#### **CITY COUNCIL RESOLUTION 2015-70**

# A RESOLUTION OF THE CITY COUNCIL OF THE CITY OF ALBANY, COUNTY OF ALAMEDA, STATE OF CALIFORNIA, APPROVING DESIGN REVIEW FOR A RETAIL DEVELOPMENT AT 1080 MONROE STREET

#### ATTACHMENT 13 – Response to Ulan McKnight Appeal (filed 9/23/15)

SIGNAGE PROGRAM

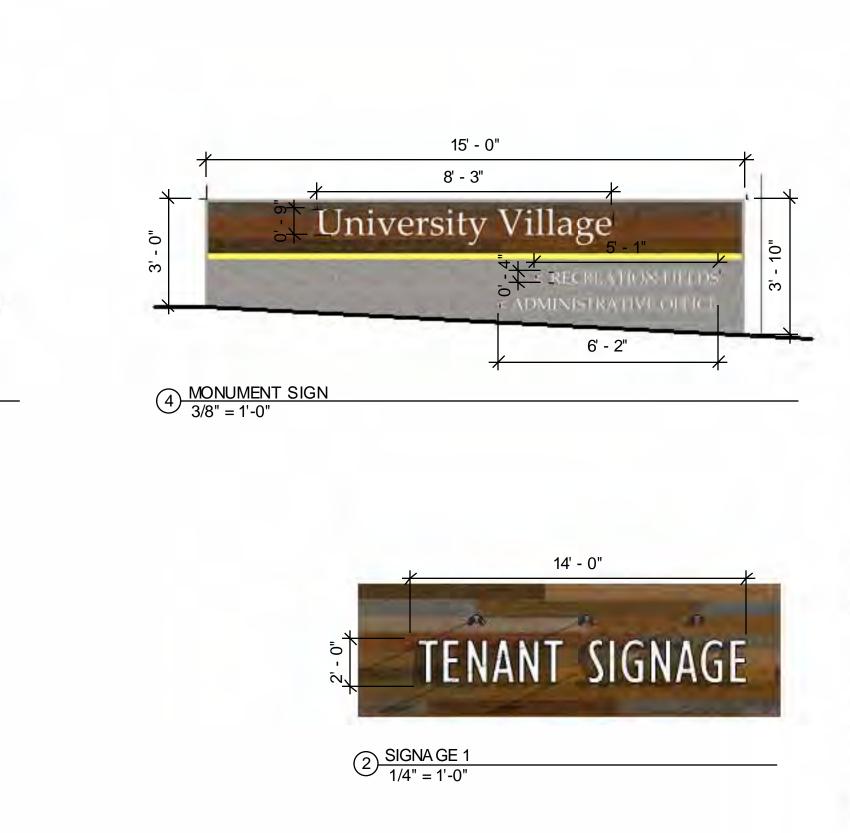
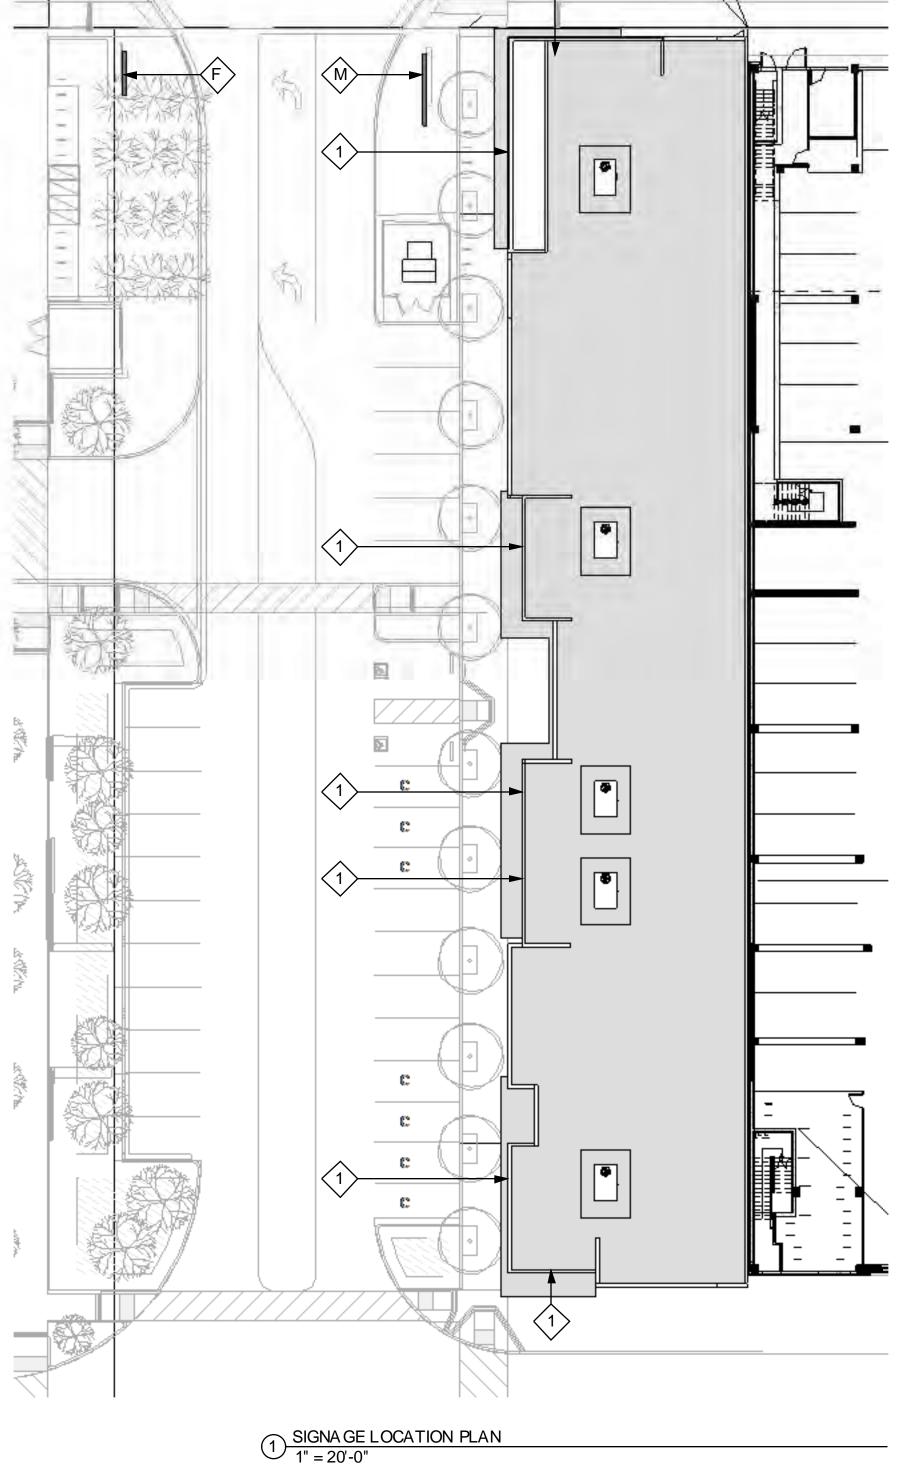
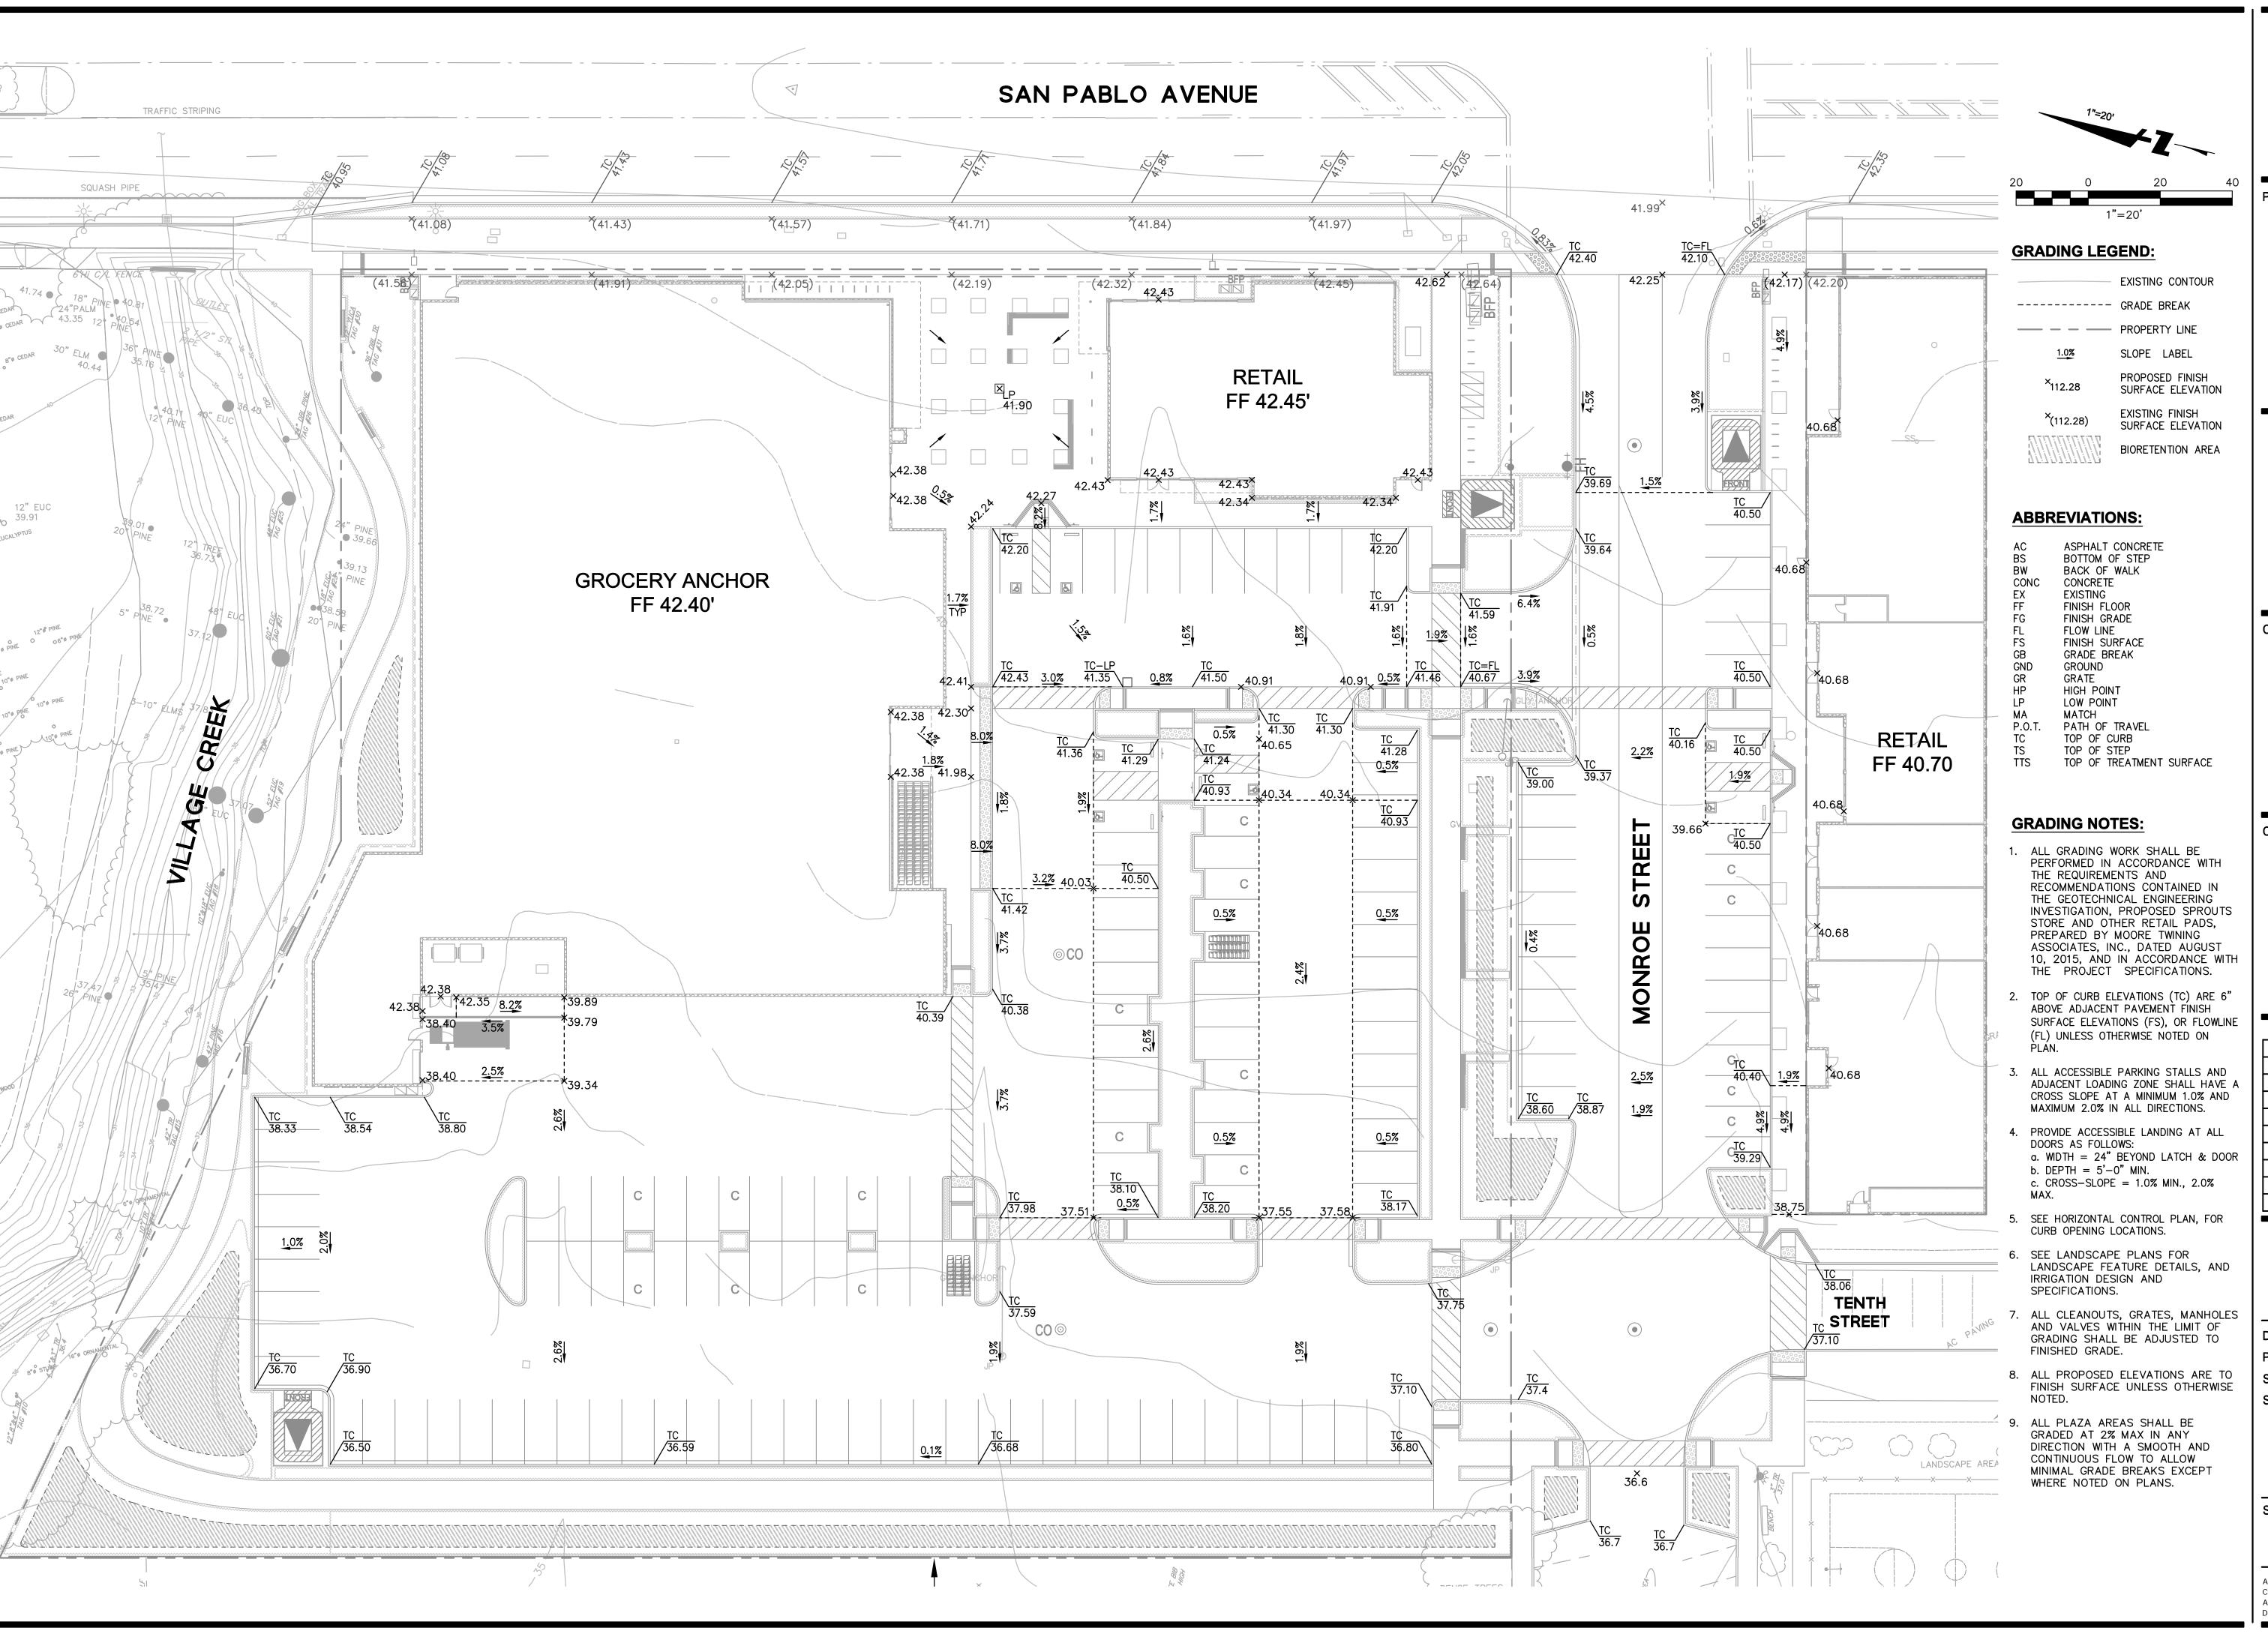
<u>Appeal Issue #4</u>: Project signage does not conform to Albany Municipal Code Section 20.32 for what is essentially a monument sign 10 feet in height; sign is not shown in plan view and not evaluated for potential obstruction of pedestrian and vehicle line of sight; signage is not located on the project site.

The appellant is correct that the proposed monument/freestanding sign was not shown in plan view; the applicant has provided a plan view of the sign on the plan set attached in Attachment 4 (Sheet A10.1). Staff shared the appellant's concerns about the visibility between drivers, bicyclists, and pedestrians at the corner of Monroe St. and San Pablo Ave. and as a result included the following condition of approval on the project. A clarifying edit is recommended as shown in strikeout/underline below.

The project applicant has continued to refine the sign proposal to meet City Code and has worked with Planning and Transportation Division staff to properly locate the sign to avoid obstructing sightlines for vehicles, bicyclists, and pedestrians. As shown in the plan set in Attachment 6 (Sheet A10.1), the current proposal is a freestanding sign proposed on two 2-foot
